# Cowal Gold Operations Underground Development Project/Modification 16 Submissions Report

## Submissions Report

J190140 RP23

**Figure 4.16** Surveyed peak hourly traffic volumes

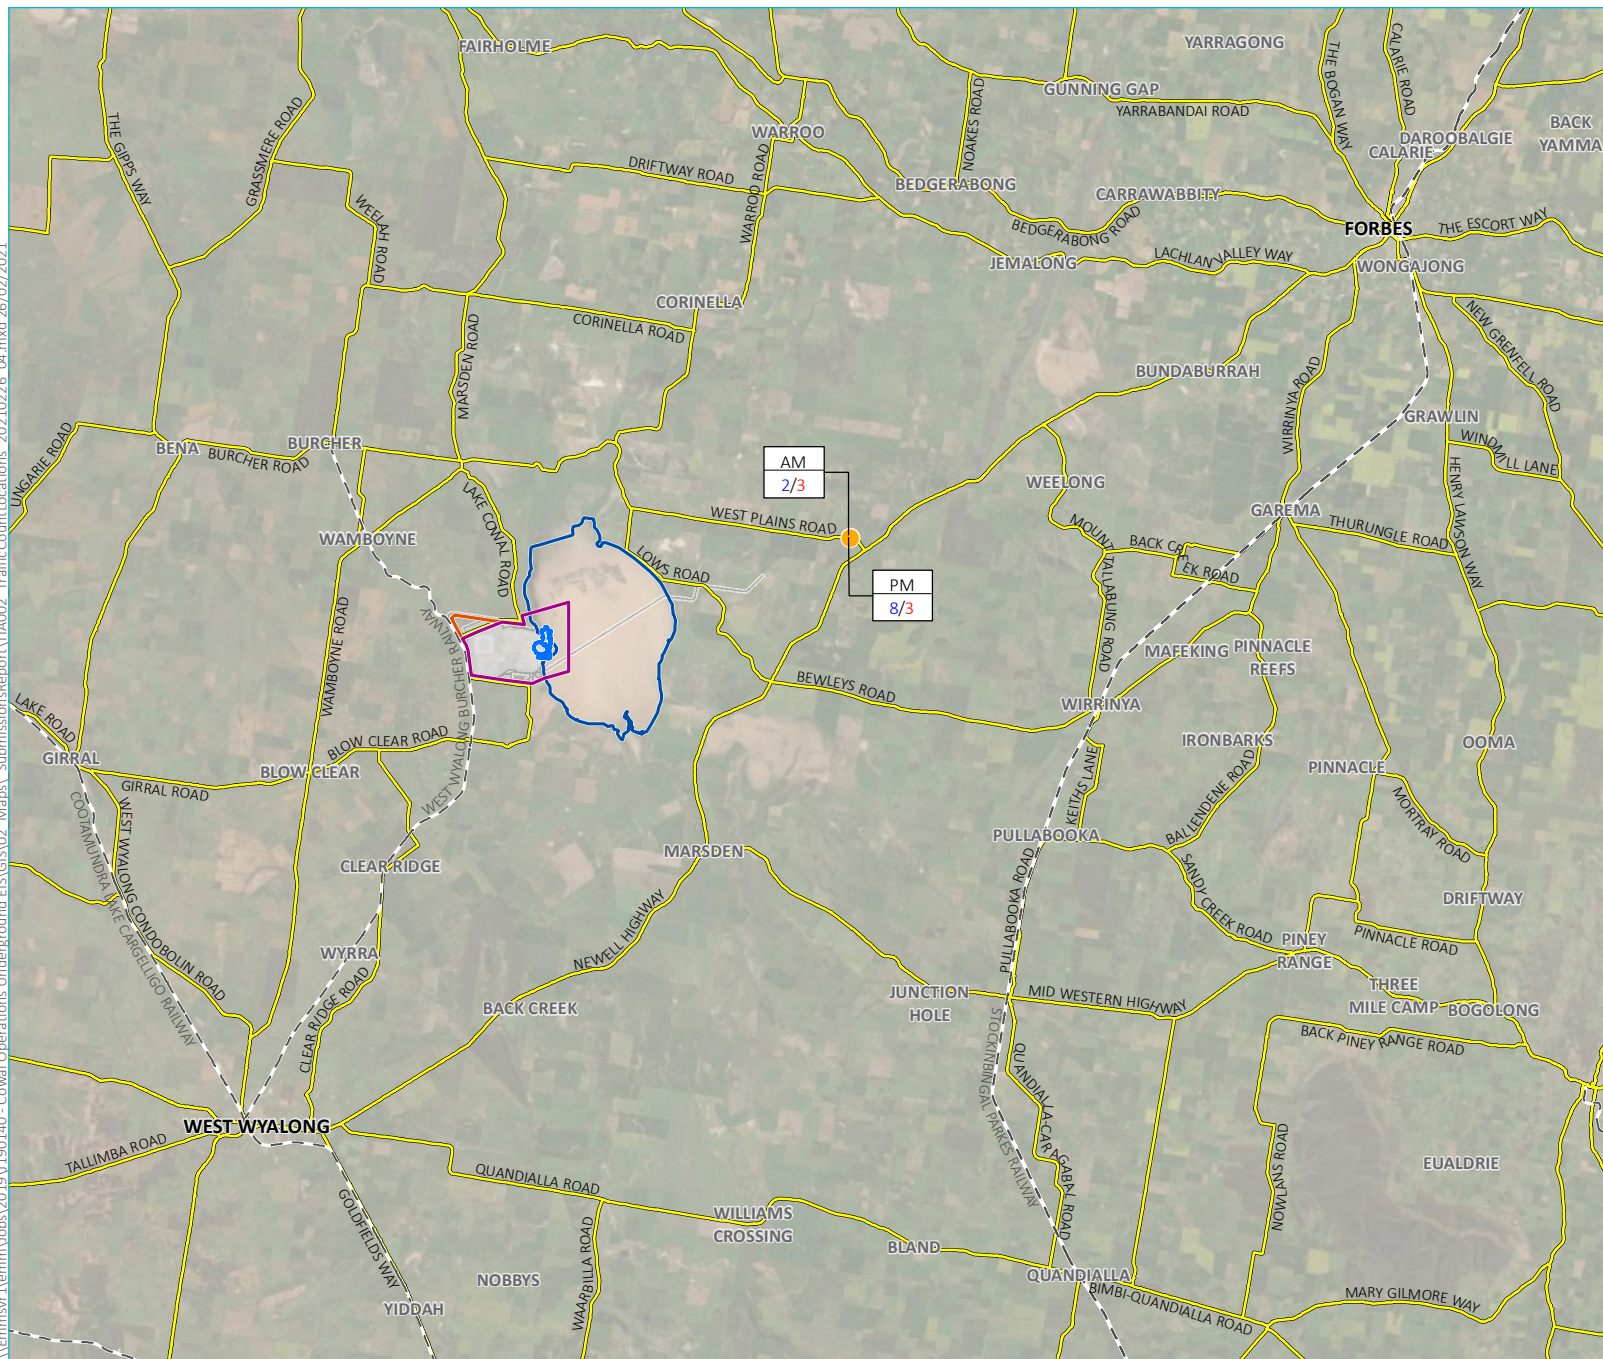
- Prior to the commencement of any onsite construction work the intersection of the Newell Highway and West Plains Road are to be upgraded to provide a BAR treatment and BAL treatment to the satisfaction of TfNSW and FSC and in accordance with Austroads Guide to Road Design (Austroads 2017).

The surveyed traffic volumes for these two peak hours are presented in Figure 4.16. The traffic count location is shown in Figure 4.17.

Figure 4.16 shows that during the surveyed AM peak a total 3 vehicles arrived from the direction of Forbes and during the PM peak 6 vehicles exited to that direction. There were no mine related vehicles from the direction of West Wyalong during these times. Turning volumes to/from the north which were most likely to be mine related and represents around 7% of the total traffic counted during both the peak hours.

Figure 5.1 Model mass balance error for the updated and original models (Coffey 2021c)

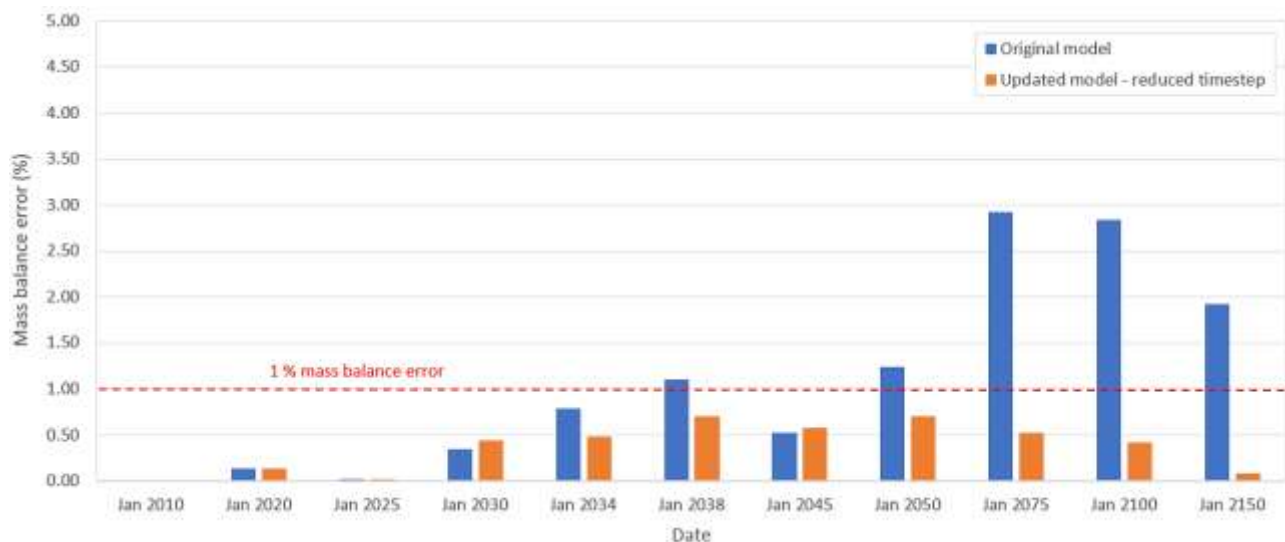
- Documentation on the updated mine site model performance with an improved water balance error term (<1% for all times).
- Information on modelled and measured groundwater levels for observation bores near the eastern edge of the lease, including: GW704031, GW704252, GW703223, GW703225 (Figure 6-7 of Coffey 2020a).
- Further detail on the components of the water balance, notably components of discharge via dewatering bores, and via seepage faces at the pit walls and floor, and via horizontal drains, and leakage from the lake that is captured by the mine, including differences during lake full and empty periods.
- If still relevant given the above, improved justification of the very steady mine inflow rate predictions compared to the high variability in reported inflows, and why it is acceptable for the model to be benchmarked to 'groundwater inflows' only during dry periods.

The numerical groundwater model was updated to have a reduced maximum time step, in order to reduce the model mass balance error. Figure 5.1 shows the resulting model mass balance error for the updated model. This can be seen to be below 1% throughout the model calibration (to 2020) and predictive periods. The original model mass balance error is also shown in Figure 5.1. Figure 5.2 shows the model time steps for the original and updated models.
